To:	IQ Student Accommodation	Job number:	2925
From:	Civic Engineers	Date:	25/09/2023
Subject:	Echo Street, Manchester, Planning Condition No 7	Cc:	XX

Echo Street, Manchester, Planning Condition No 7

This file note is produced in response to the Decision Notice Ref; 136874/FO/2023 and Planning Condition No 7 and the specific requests as follows;

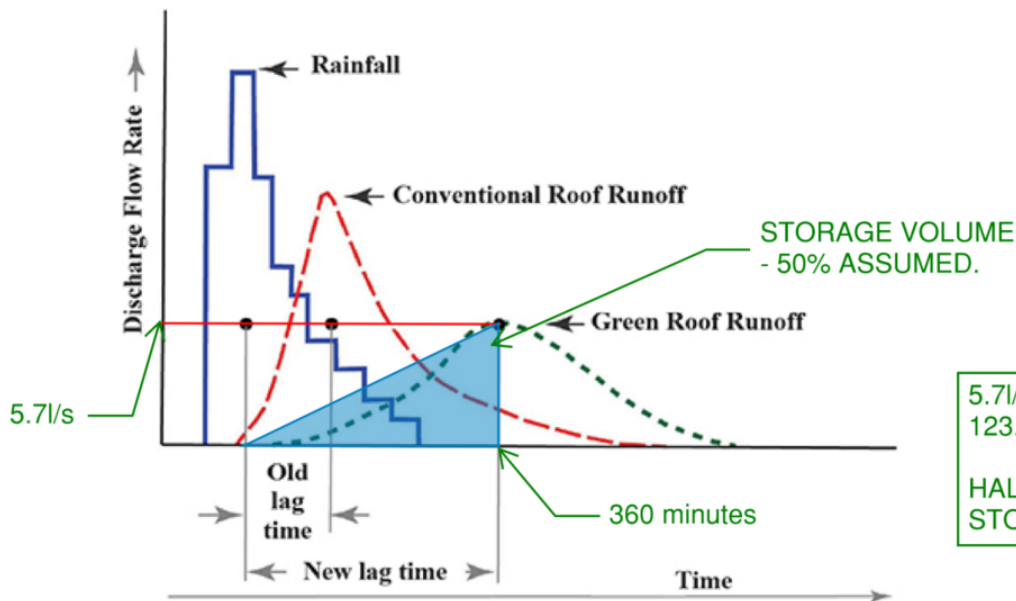
"Runoff volume in the 1 in 100 year, 6 hours rainfall shall be constrained to a value as close as is reasonable practicable to the greenfield volume for the same event, but never to exceed the runoff volume from the development site prior to redevelopment."

In reference to the above please see below table indicating the surface water discharge volumes for the 1 in 100 year 6 hours rainfall event:

<i>Pre-development Volume document reference - 2925 Echo Street Ex 100Yr 6Hr Volume</i>	<i>155 m³</i>
<i>Post-development Volume - document reference - 2925 Echo Street SW Calcs - 100Yr 6Hr Storm and Hydrograph calculation below.</i>	<i>40m³ non green/blue roof areas +61.6 m³ = 101.6m³</i>

Greenfield Volume – document reference - 2925 Echo Street Greenfield - 100Yr 6Hr Storm

95m³

Refer to Green Roof Hydrograph 1 in 100 year surface water storage calculation.

$$5.7\text{l/s} \times 360\text{mins} \times 60\text{secs} / 1000 = 123.12\text{cu.m}$$

HALF ABOVE FOR 1 in 100 YEAR STORAGE VOLUME = 61.56cu.m
